D240002: New Zealand Transport Agency Notice of Requirement SH 1 Rolleston Access Improvements

Request for further information

A	FOR INFORMATION	---	---	---	
No.	Revision	By	Chk	Appd	Date

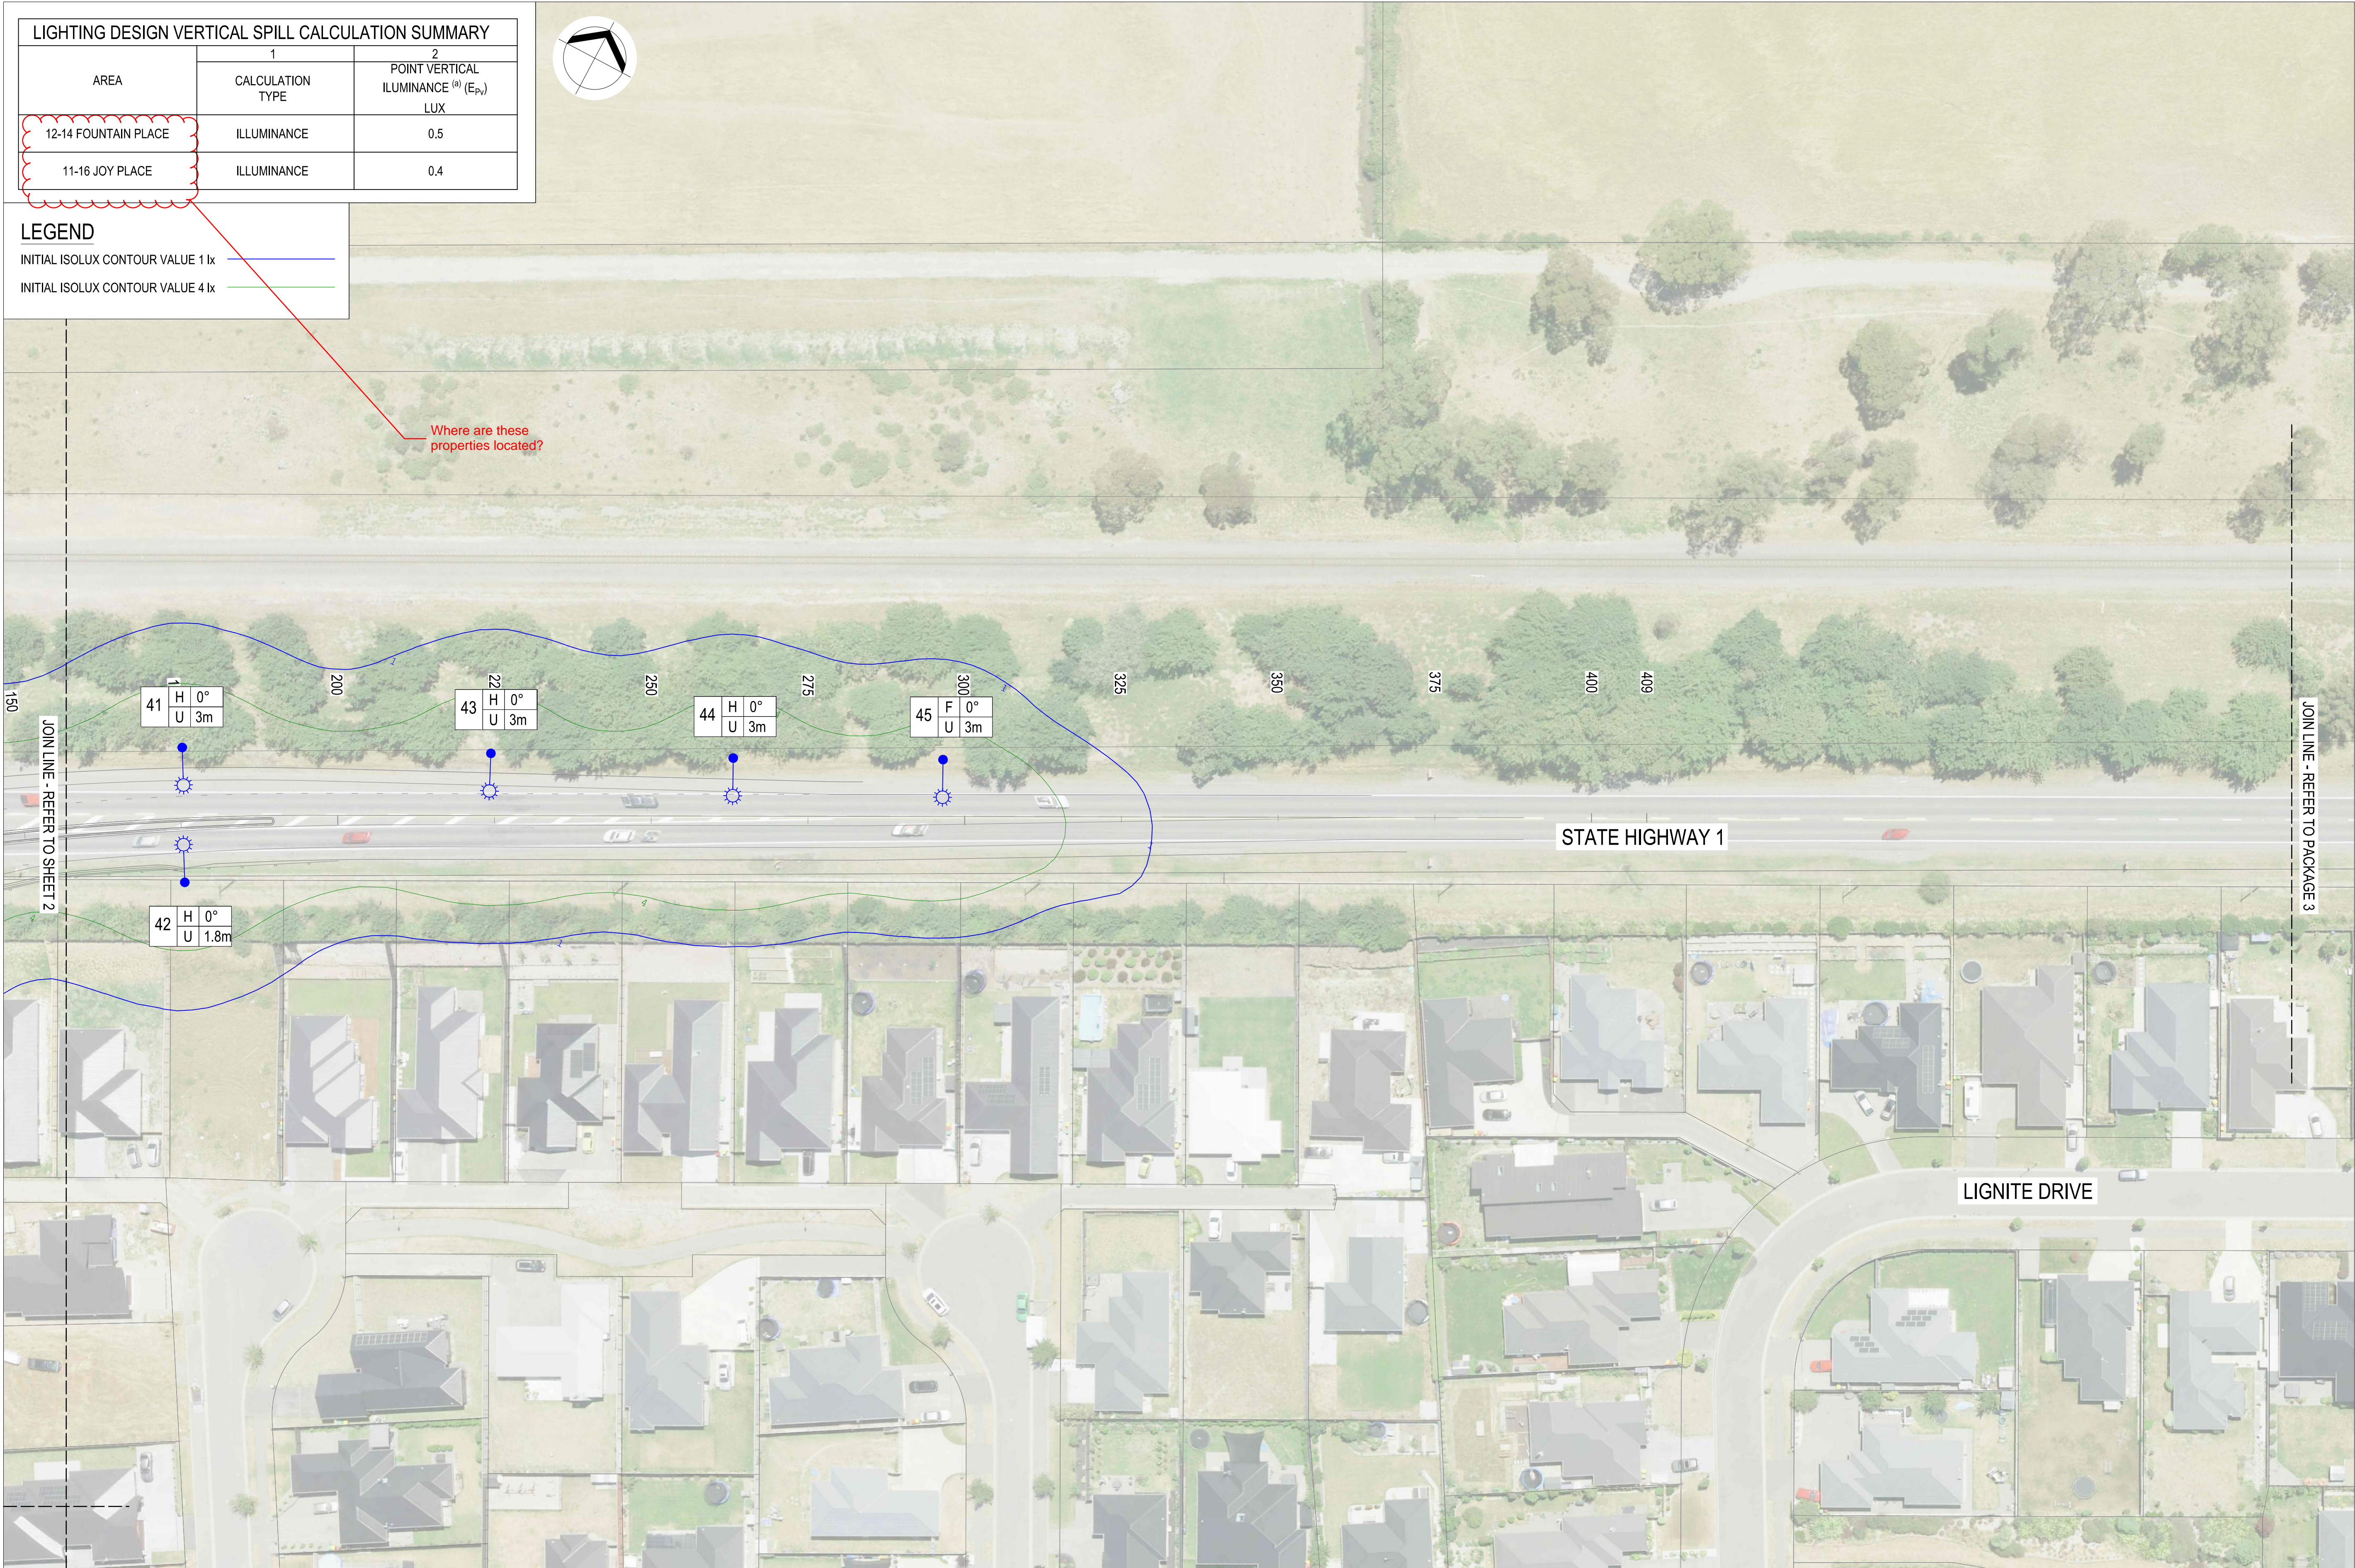
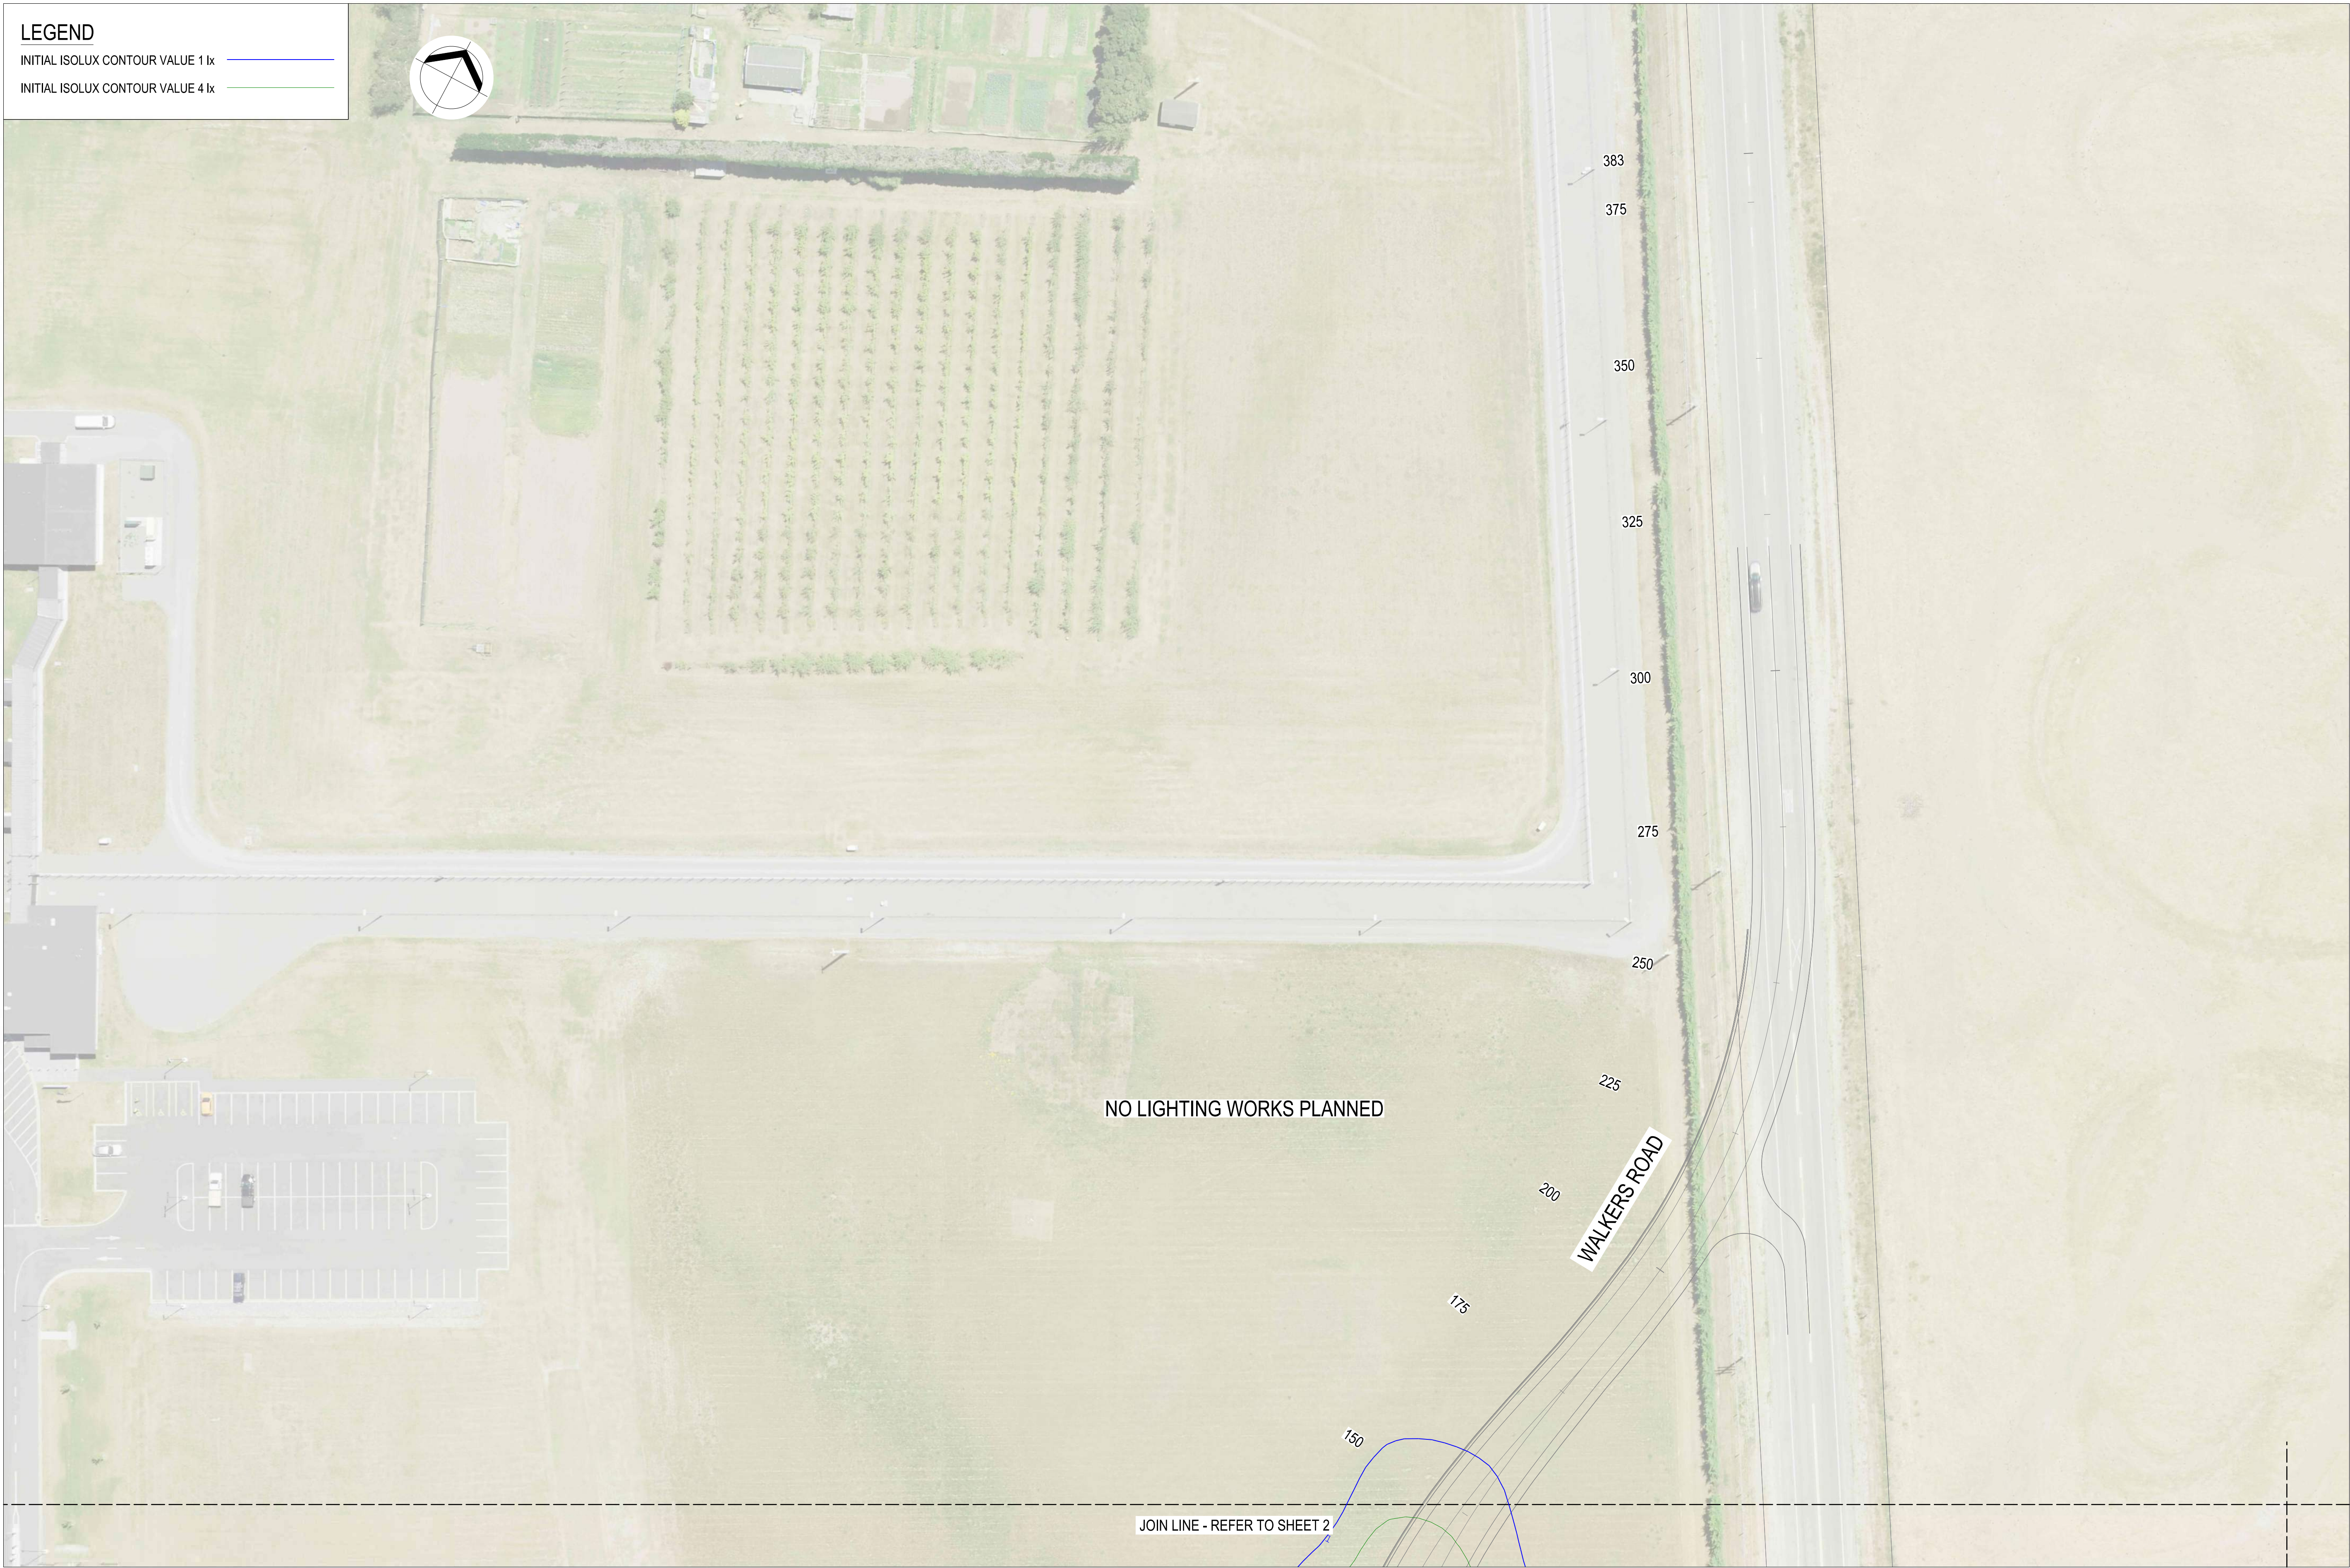
24. Drawings 3338703-10-CU-3532 to 3534 - These drawings show spill light calculation results for certain address (e.g. 15 Fountain Place), however none of these drawings show the property numbers so there is no way to correlate the calculation results with the properties without having to look up Google maps. *Please get the lighting designer to add the street addresses to the evaluated properties.*

Figure 2.1 Potential pinch point that may prevent the “Future Reserve Path” proposed by Selwyn District Council as part of its Walking and Cycling Strategy

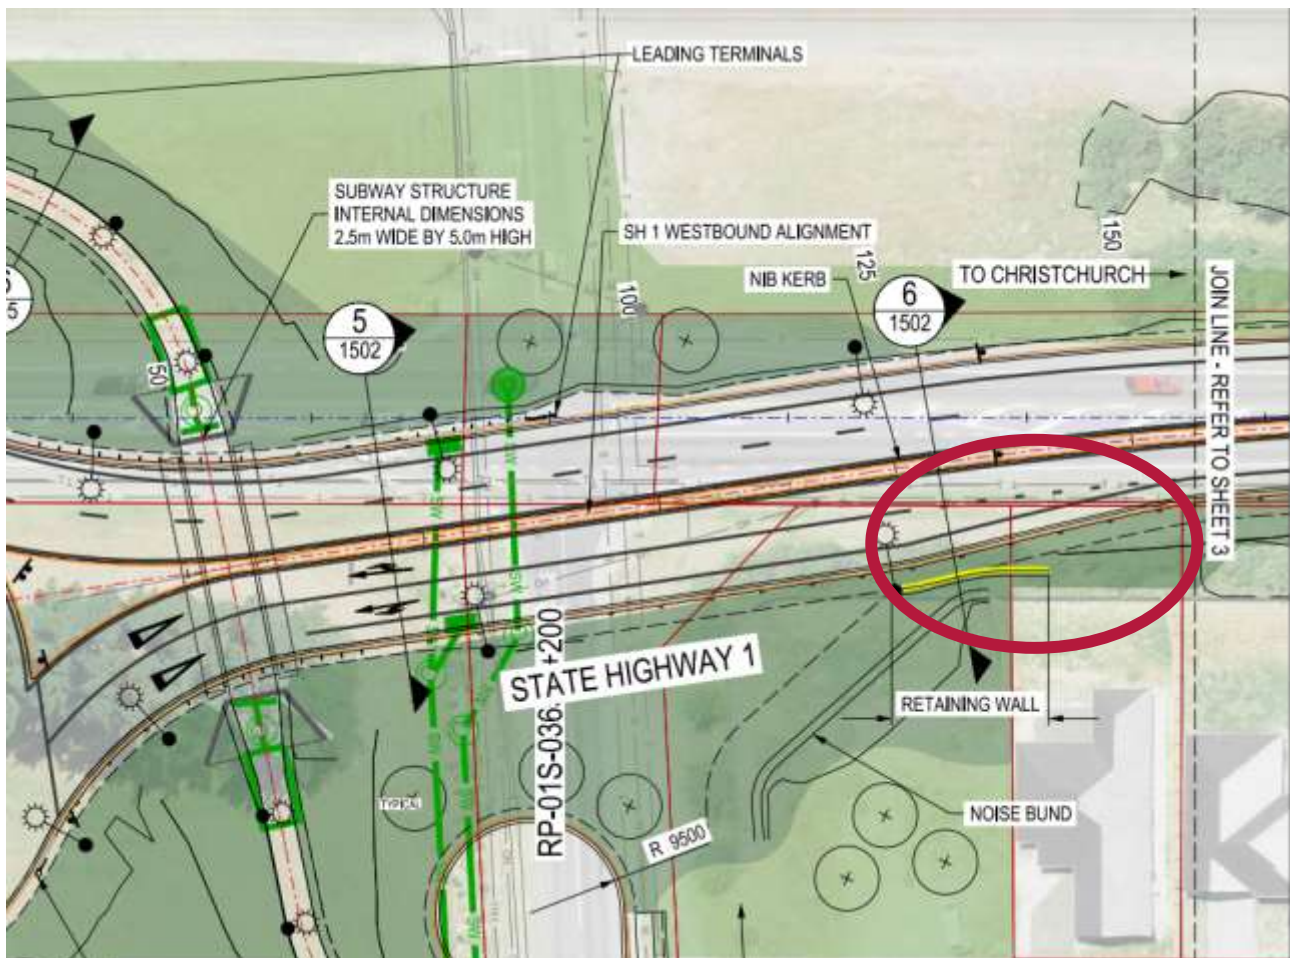
- e) **Commentary on whether the pinch point, shown in Figure 2.1, forecloses the opportunity to provide the “Future Reserve Path” proposed by Selwyn District Council as part of its Walking and Cycling Strategy (and shown in Figure 5-10 of the ITA).**

Figure 2.2 Narrowed carriageway of Old Dunns Road South

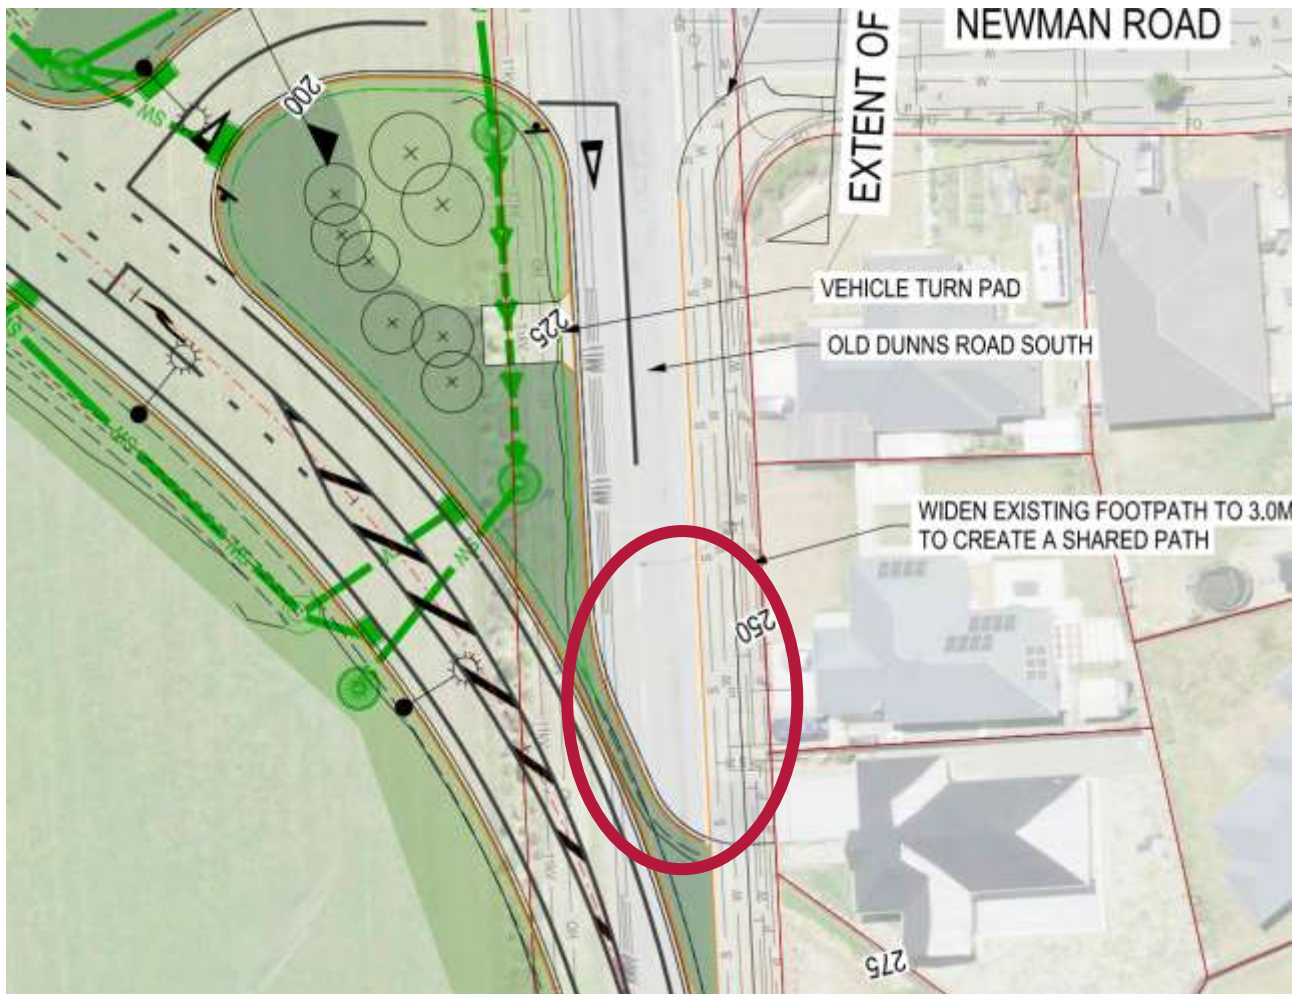
- g) **Heavy vehicle tracking for “Old Dunns Road South”, demonstrating whether a waste collection truck can turn around within the new stub road.**
- h) **85th percentile car tracking for 388 Dunns Crossing Road, and confirmation of whether changes to the existing vehicle crossing are required due to the amended kerb line for “Old Dunns Road South”**

- i) **Commentary on the practicalities of Council having to maintain/replace the carriageway for the southern section of “Old Dunns Road South” in the vicinity of 388 Dunns Crossing Road, shown in Figure 2.2, as the tapering of the carriageway may lead to accumulation of debris and difficulty for laying new carriageway surfacing.**
